### VAG 1.8 20V / Synchronous Drive / Parts Info.

<b>GATES REFERENCE:</b>	<b>5425XS, 5492XS its related kits.</b>	
<b>MAKE:</b>	AUDI / VOLKSWAGEN.	
<b>MODEL:</b>	A4, A6, Cabrio, Passat.	
<b>MOTOR:</b>	1.8 20v, 1.8 20v T.	
<b>MOTOR CODE:</b>	ADR, AEB, AFY, AJL, ANB, APT, APU, ARG, ARK, AVV, AWT.

Fig. 1

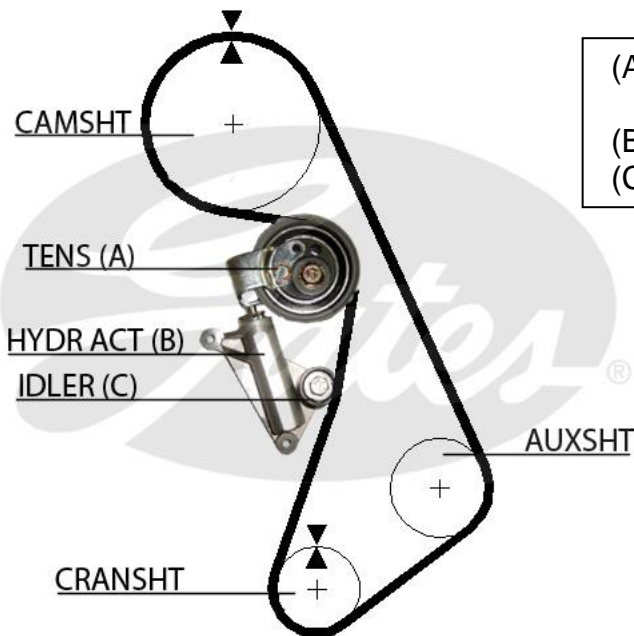
Having durability issues it was decided to reengineer the synchronous drive system and to use an OE belt 058109119B / 058109119C (5492XS - 153 teeth) together with a hydraulic actuator <sup>(2)</sup> 058109479B and a new tensioner pulley 058109243E (new system see further: Fig. 1).

The old system is no longer available on OES level. It is strongly recommended to replace the entire system with the new system (Fig. 1) when the original timing belt needs replacement. Please make sure that parts of the old and new system are not being interchanged in order to avoid engine damage.

- (A) Tensioner 058109243D or 058109243E
- (B) Hydraulic Actuator 058109479B
- (C) Idler 058109244
